TEXAS INSTRUMENTS **12500 TI Boulevard, MS 8640, Dallas, Texas 75243**

PCN# 20250922000.2
Qualification of TIEM as an additional Assembly & Test site for select devices
Change Notification / Sample Request

Date: September 22, 2025
To: MOUSER PCN

Marking differences sample:

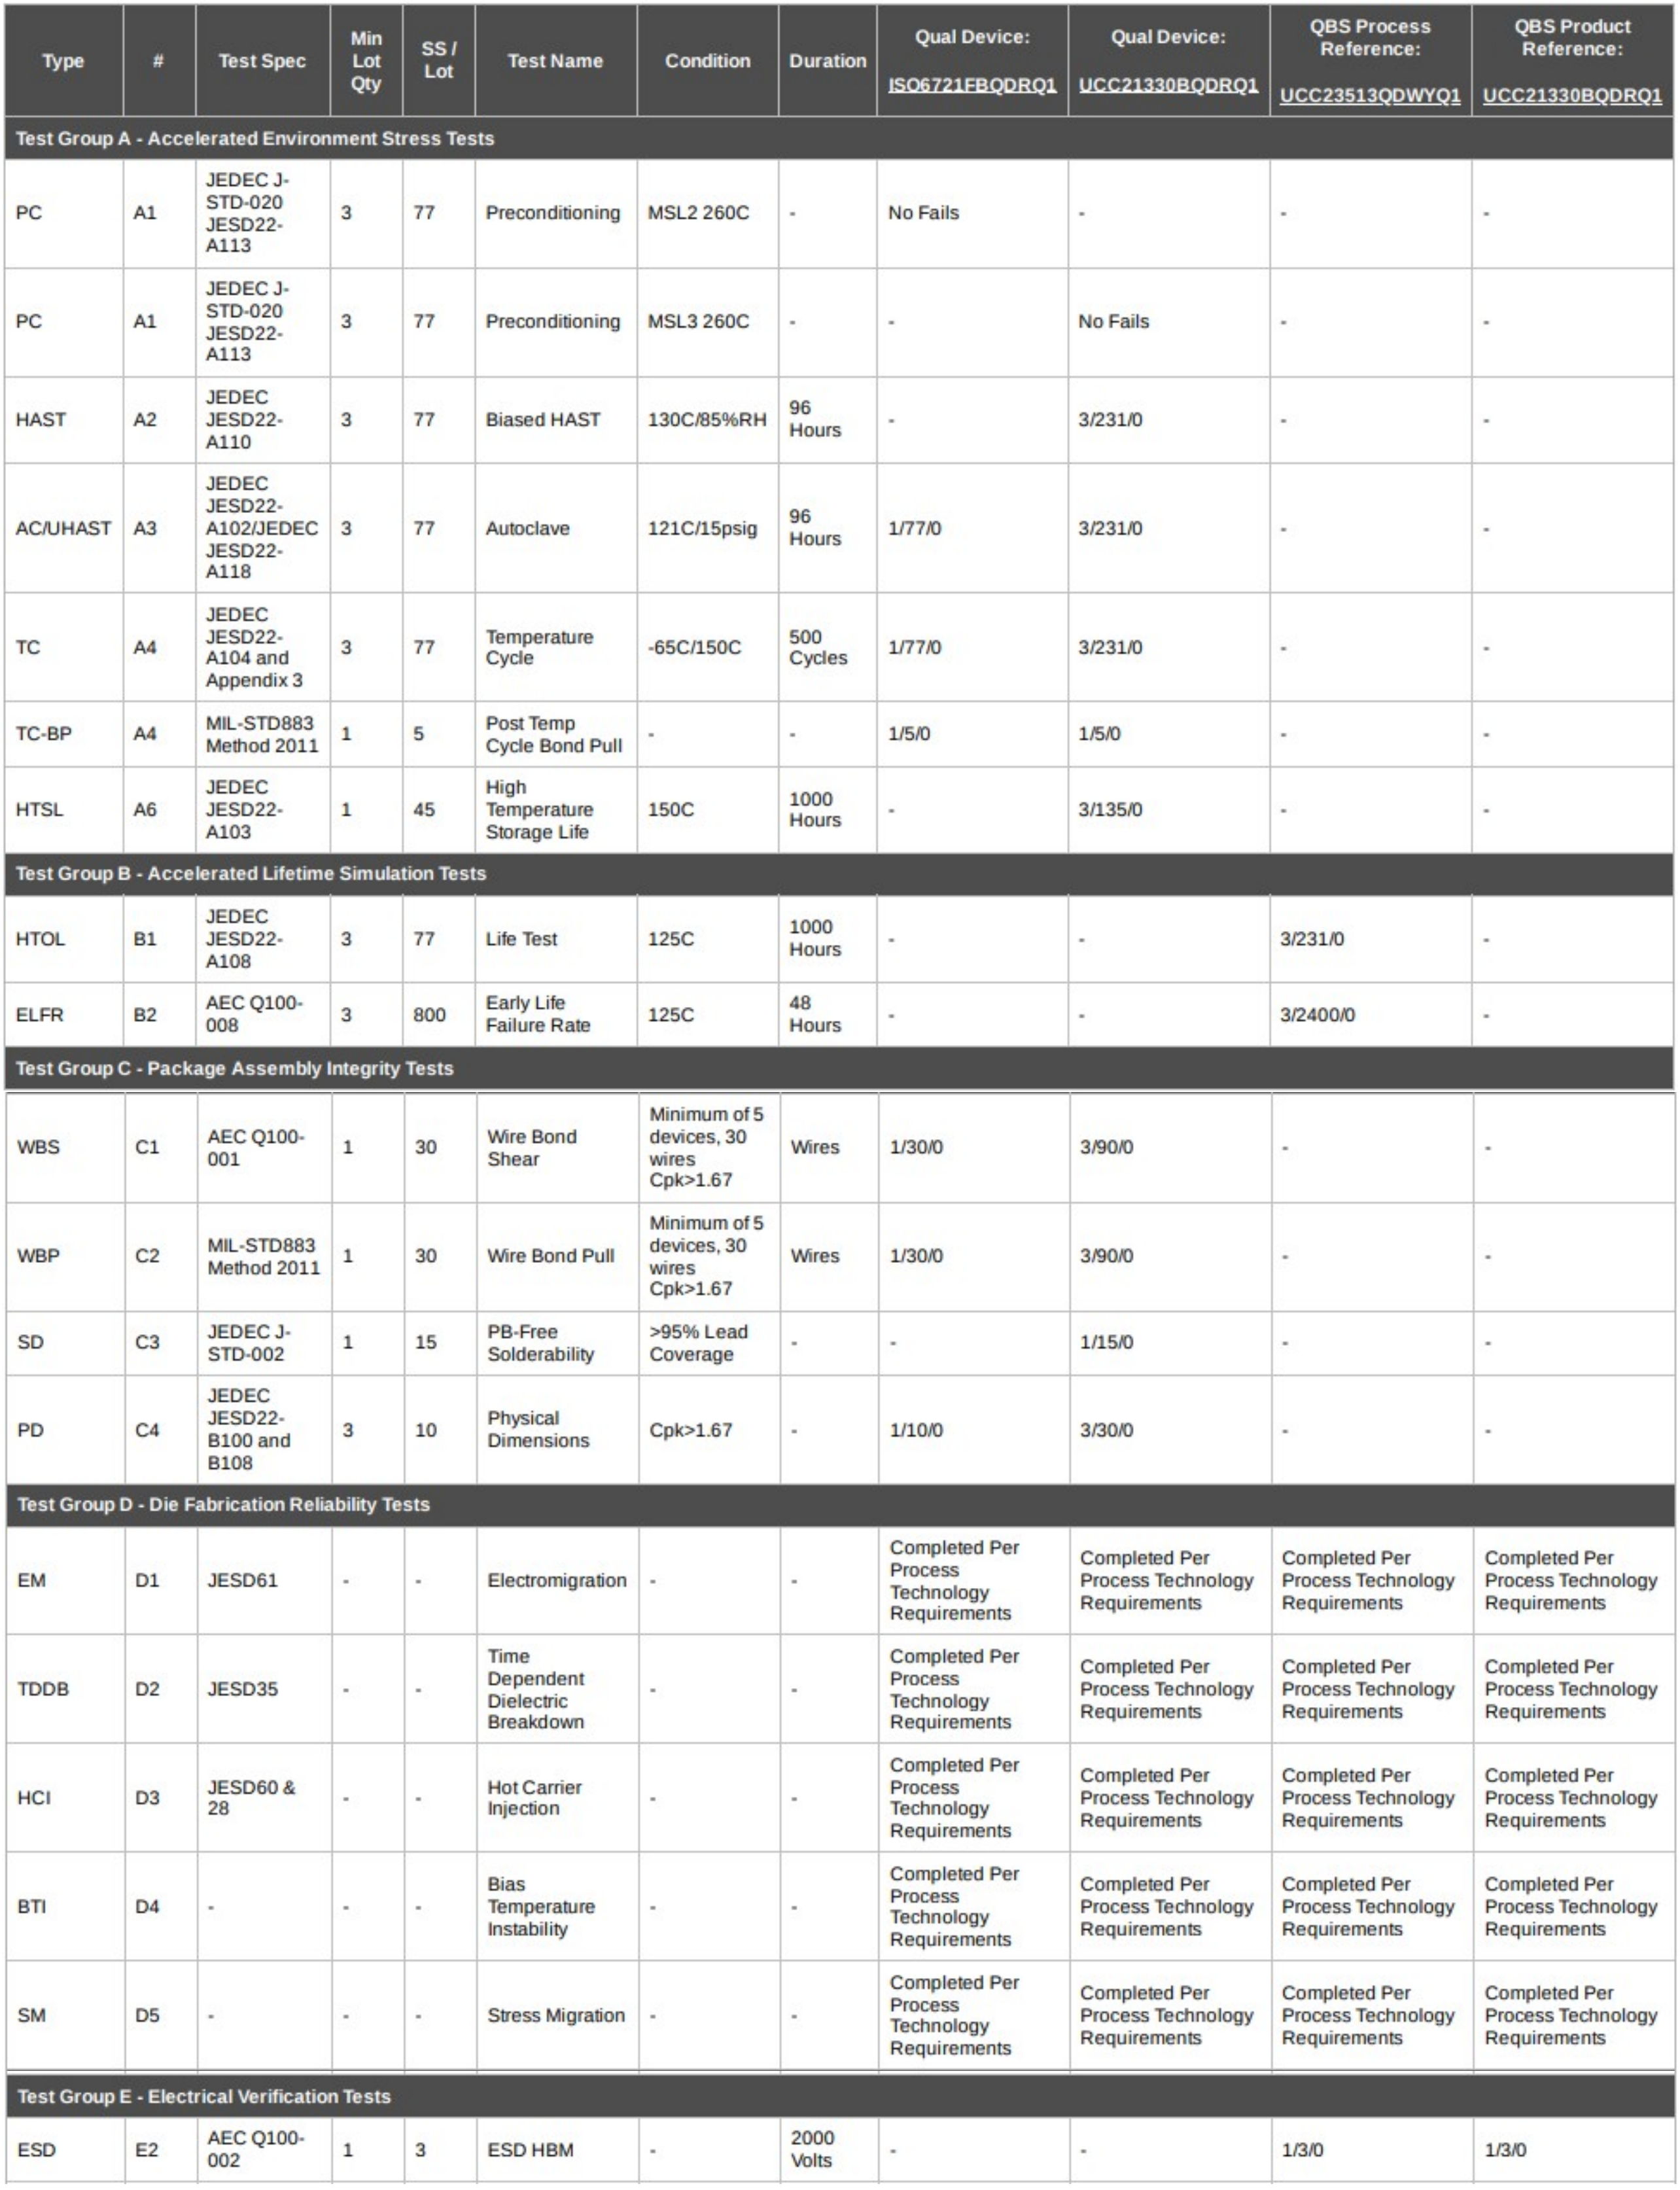
Texas Instruments is pleased to announce the qualification of TIEM as an additional Assembly & Test site for select devices. Assembly differences are as follows:

Current A/T site		Additional A/T site
	TITL	**TIM**	**TIEM**
Wire diam/type	0.96mil Au	0.96mil Au, 1.0mil Cu	0.8mil Cu
Mold Compound	4209640	4211880	4211880
Marking differences	TI logo, pin 1 stripe, with G4	TI logo, pin 1 dimple, without G4	TI letter, pin 1 dot, without G4
